July 17, 2014

**BOARD OF COUNTY COMMISSIONERS  
ORANGE COUNTY, FLORIDA**

**ADDENDUM NO. 9 / IFB NO. Y14-792-PH**

**EAST SERVICE AREA POTABLE WATER AND RECLAIMED WATER STORAGE  
AND REPUMP FACILITY**

PROJECT NO.:	110005
SCALE:	NOTED
DRAWING NO.:	C06
REVISION:	D
SHEET NO.:	011 OF 108

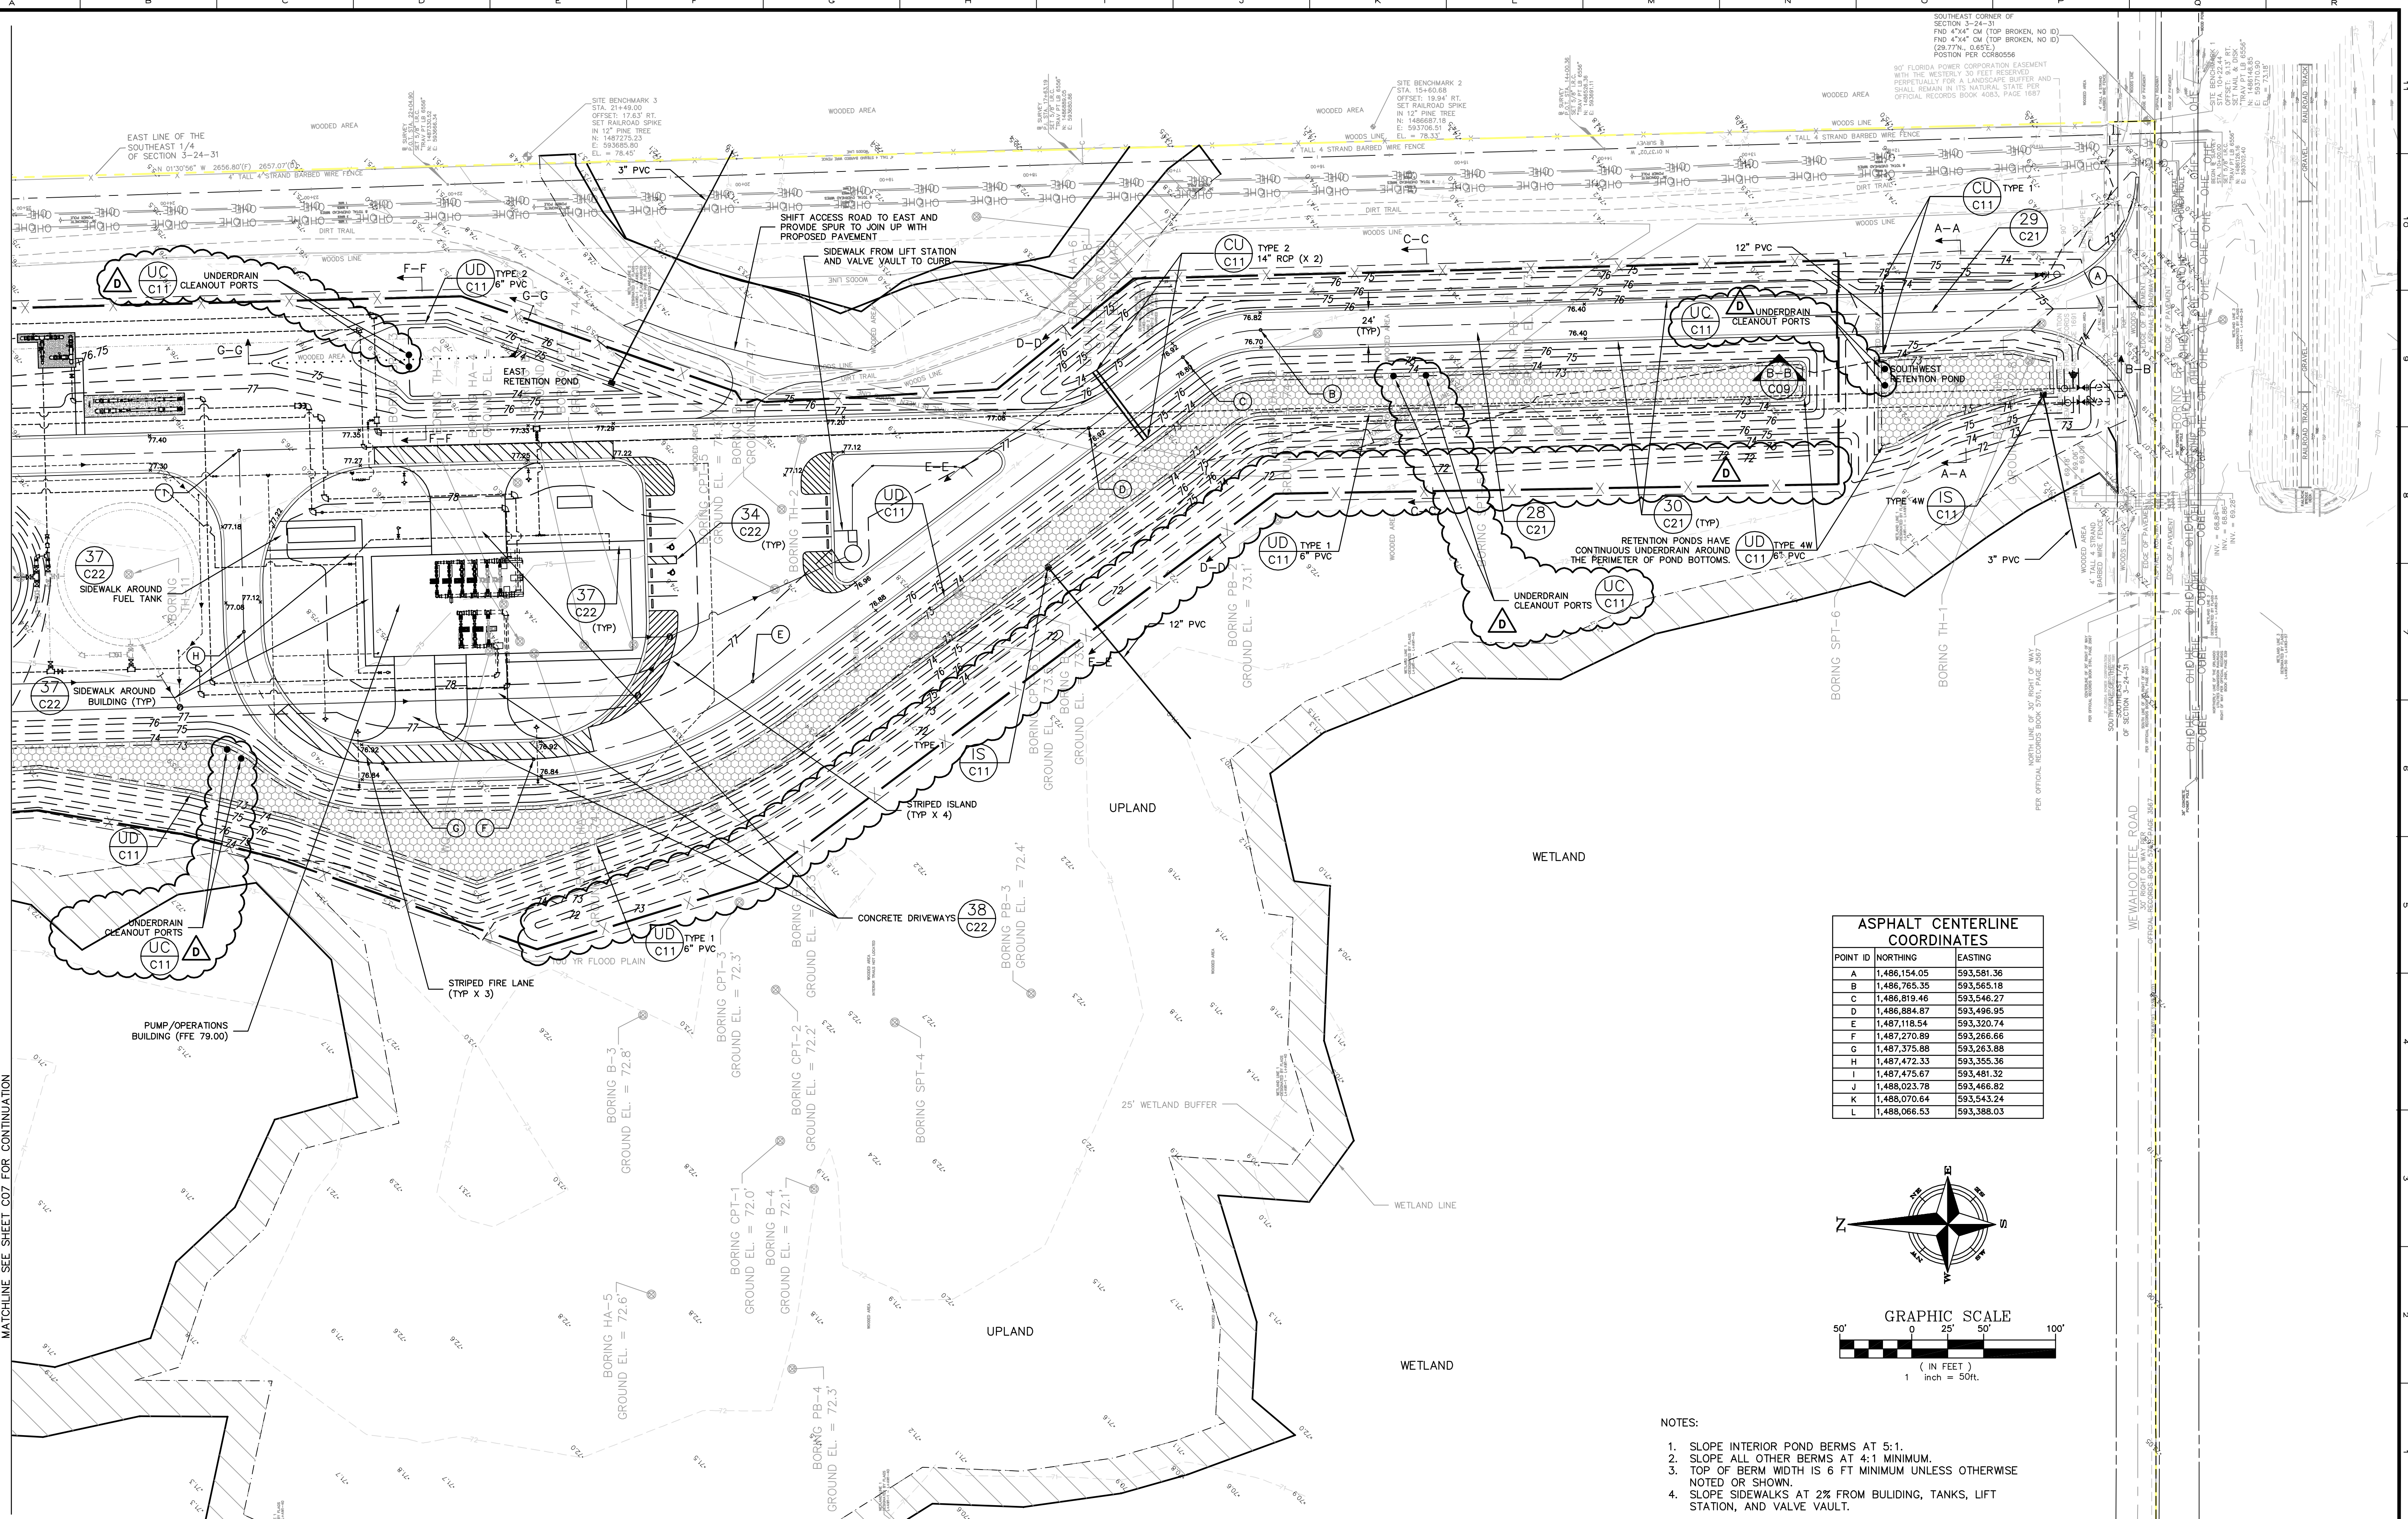
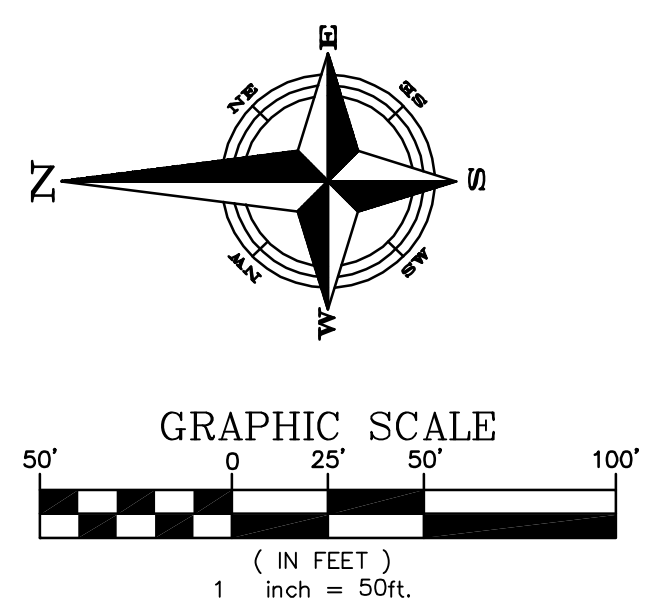
7. **Drawings C06 and C07 call for the pond underdrain to be PVC. Please specify the type of PVC to be used.**

Answer: The PVC pipe shall be ASTM D3034 Solvent Weld SDR35 perforated underdrain pipe with two rows of holes 1/2-inch in diameter on 5-inch centers and 120 degrees apart.
